Appeal 2018-007742  
Application 29/430,805  
Technology Center 2900

DECISION ON APPEAL

The Appellant claims “[a]n ornamental design for an ice cream product” (Appeal Br., Claims App.), a perspective view of which is provided below.

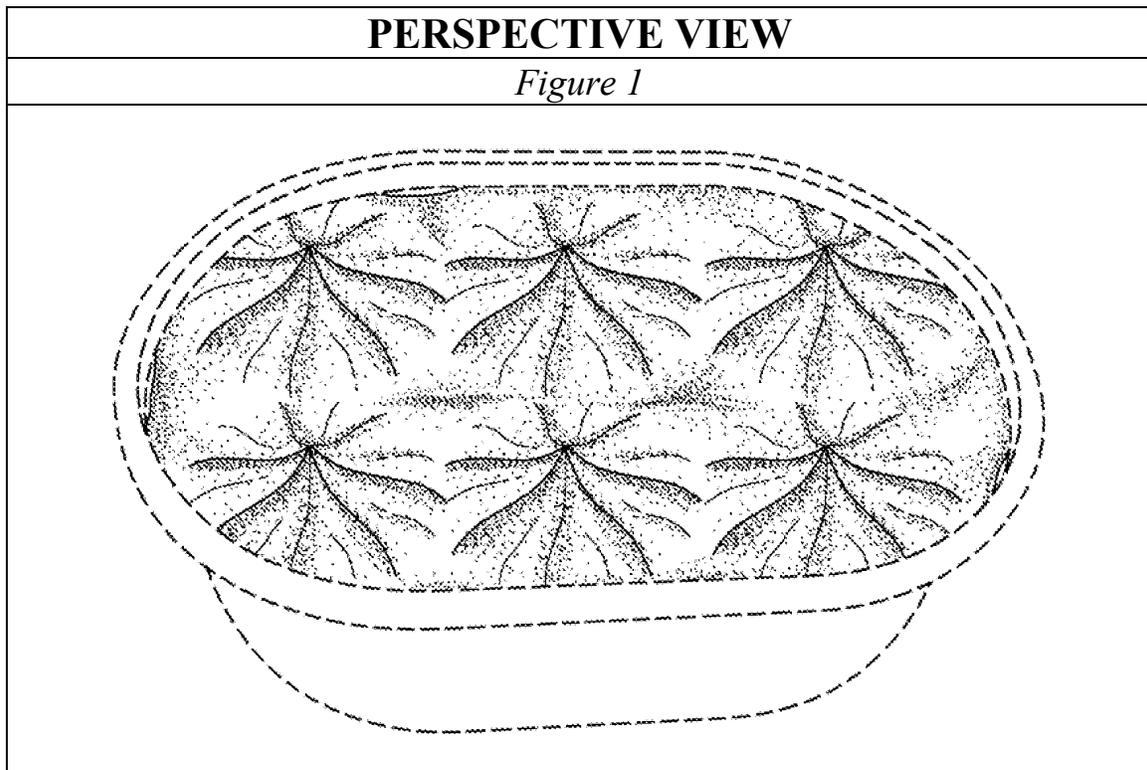
This drawing shows the ice cream product enclosed by a tub-shaped container depicted by broken lines,<sup>3</sup> and this drawing shows shading on the top surface of the ice cream product. The Examiner and the Appellant agree that the illustrated shading portrays a three-dimensional pattern of “rosettes” and that this rosette pattern is the “dominant feature” of the claimed design. (See Appeal Br. 7, Final Action 2.)

The Examiner rejects the claim on appeal under 35 U.S.C. § 112, first and second paragraphs. (*See* Final Action 2.) The Examiner determines that “[t]he claim is indefinite and nonenabling” because “the exact appearance of the claimed design cannot be fully understood in view of the drawings.” (Answer 2.) According to the Examiner, the Appellant’s drawing disclosure does not provide “enough information” to understand “the [relative] height of rosette peaks” and/or “the numerous surface undulations” in the rosette pattern. (*Id.* at 5.)

Here, the Examiner is troubled by dimensional details that could only be precisely discerned by a close inspection of regions of the ice cream product located “below the top lip of the unclaimed container.” (Answer 5.) We do not necessarily disagree that the precise parameters of these dimensional details might be difficult to decipher from the Appellant’s perspective view of the ice cream product. And we do not necessarily disagree that the parameters of these dimensional details could have been precisely disclosed by a multitude of sectional drawings taken along the width, length, and height of the ice cream product.

We determine, based on this observation, that the precise parameters of geometries located below the container’s top lip are not necessary to understand the scope of the claim. Thus, we disagree with the Examiner that, here, the requirements of 35 U.S.C. § 112 cannot be satisfied without “an exact understanding of the complexity and the specifics” of the top surface of the ice cream product. (Answer 6.)

The Examiner proposes a scenario in which the rosette pattern of the claimed design is implemented in different ways by varying the relative heights of its peaks. (*See* Answer 5.) However, a similar scenario was proposed in *Maatita*, and this did not fatally impact the outcome of the definiteness and enablement analysis.

The Examiner maintains that “[b]ecause the design comprises complex undulations,” the bar to satisfy § 112 requirements “is high.” (Answer 6.) But the bar to satisfy § 112 is not set by a claimed design’s dormant intricacies, but rather by what an ordinary observer needs to know to understand the scope of the claim. Here, the Appellant’s use of shading effectively represents the contour of the undulations in the rosette pattern so as to provide an ordinary observer with a sufficient understanding of the claimed design.<sup>4</sup>

The Examiner also correctly points out that a perspective view of a claimed design is not always alone sufficient to meet § 112 requirements. (*See Answer 6–7.*) Here, however, the Appellant’s drawing disclosure additionally includes front, rear, side, top, and bottom views of the ice cream product. (*See Spec.*, Figs. 2–8.) As such, we need not belabor whether the Appellant’s perspective view of the ice cream product is alone sufficient to meet § 112 requirements.

Thus, we agree with the Appellant (*see* Appeal Br. 6–9) that its drawing disclosure satisfies the definiteness and enablement requirements of 35 U.S.C. § 112; and we do not sustain the Examiner’s rejections.
